Table 1: Responses to Comments from the Government Department on Planning Application No. A/NE-LYT/845 (14 March, 2025)

Figure 7

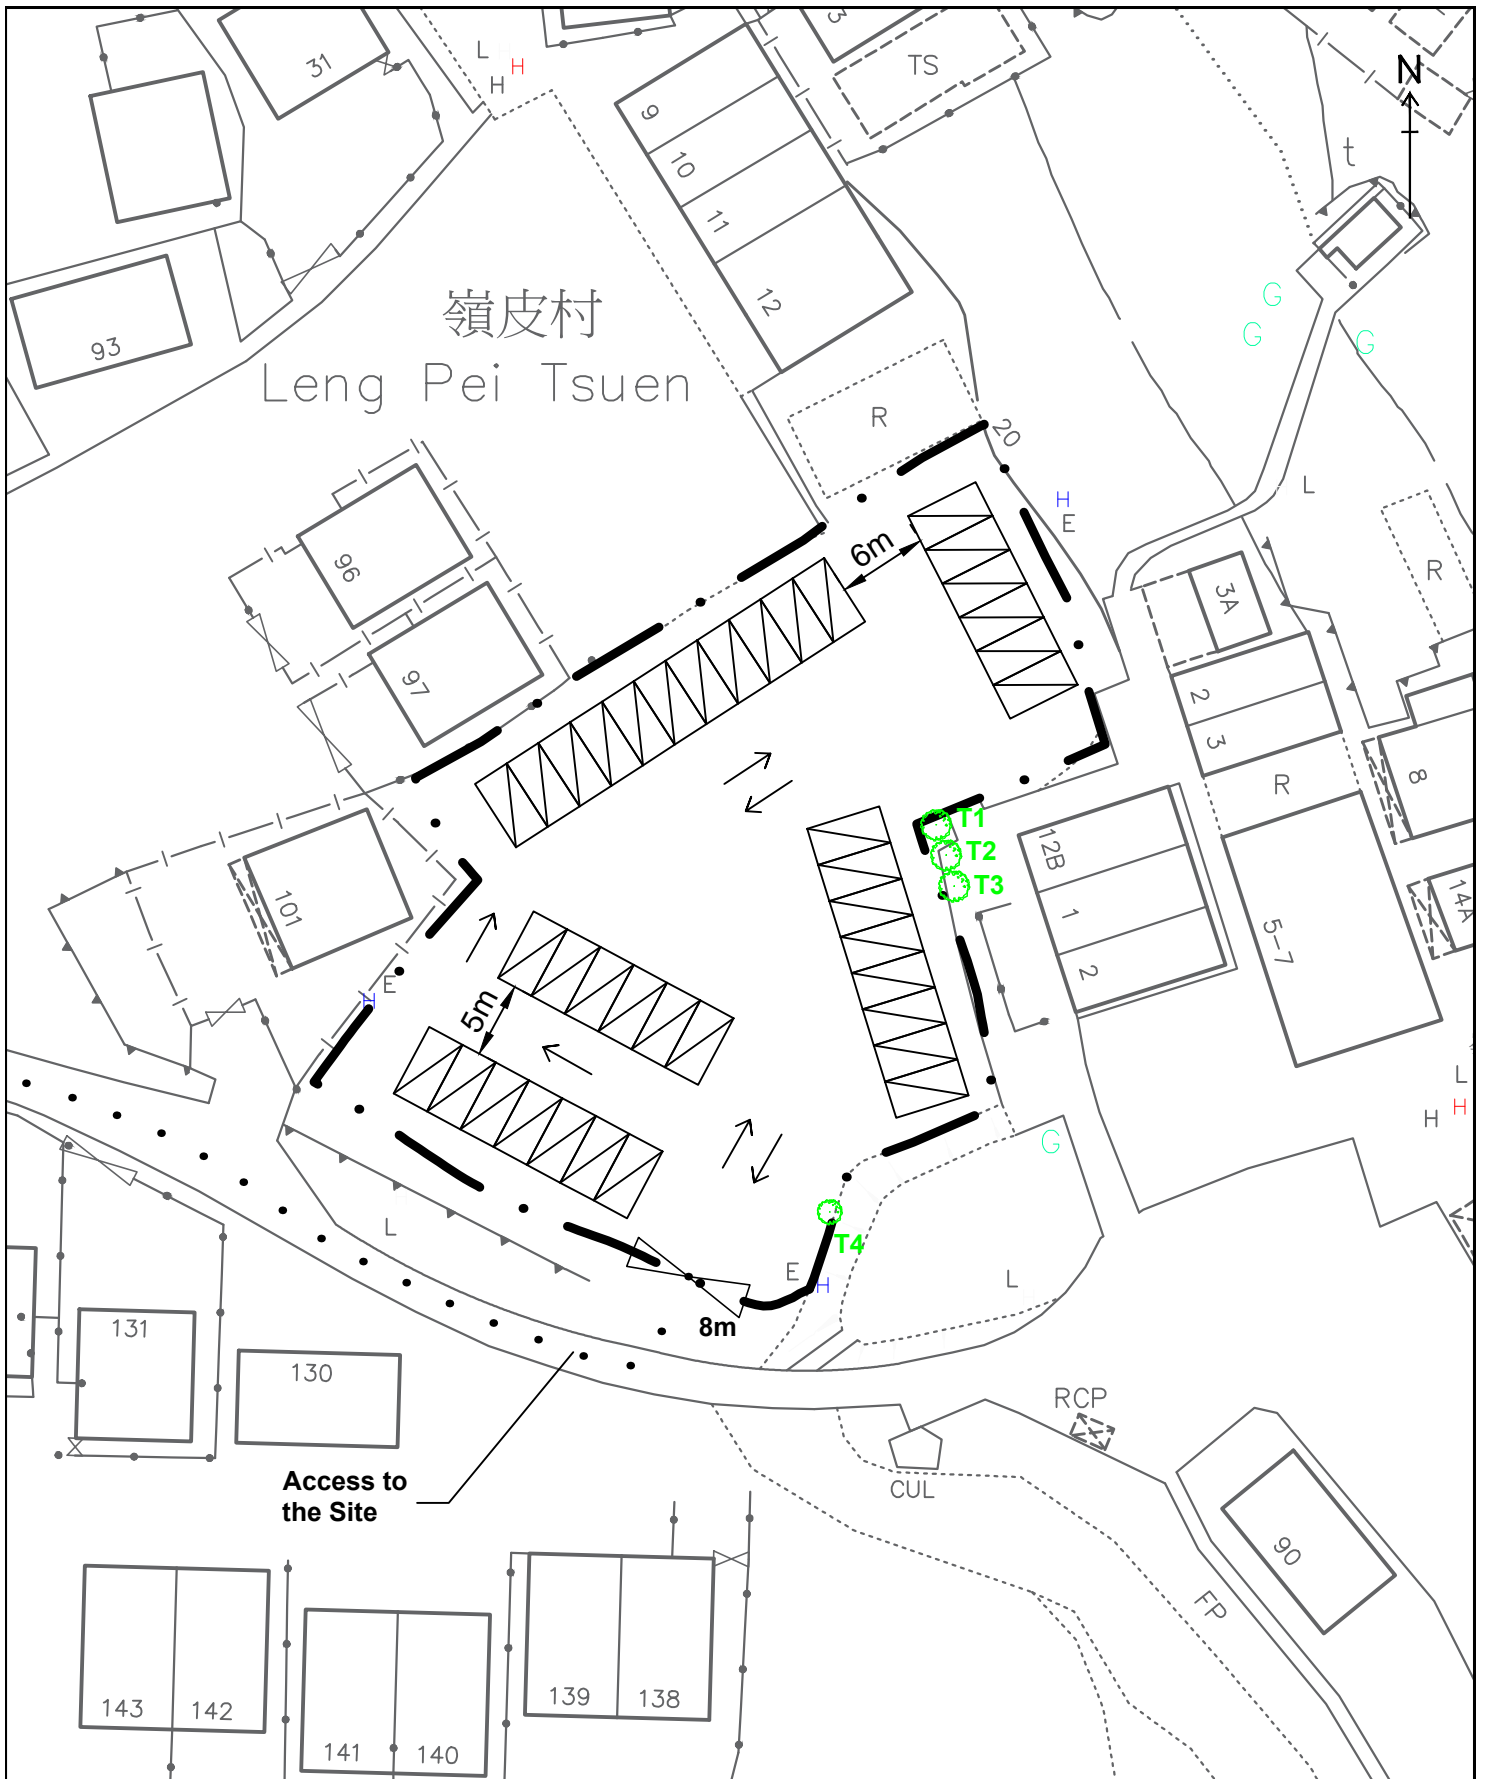
COMMENTS	RESPONSES
1. Landscape Unit, Urban Design & Landscape Section, Planning Department	
<p>(i) According to the Indicative Layout Plan (Figure 4), the proposed parking spaces along the eastern boundary is in conflict with the existing small trees/plants. The applicant is advised to review the layout and preserve the existing plants as far as practicable.</p>	<p>(i) The existing small trees/plants along the eastern boundary is shown in Figure 7 and Tree Photos. T1 to T3 are located outside the application boundary and not in conflict with the proposed parking spaces. T4 is located at the eastern boundary and no parking spaces will be provided at this location. The Applicant will ensure that the existing small trees/plants will not be affected.</p>
<p>(ii) The applicant should be advised that approval of the application does not imply approval of tree works such as pruning, transplanting, felling and compensatory/new tree planting. The applicant is reminded to seek approval for any proposed tree works from relevant departments prior to commencement of the works.</p>	<p>(ii) Noted.</p>
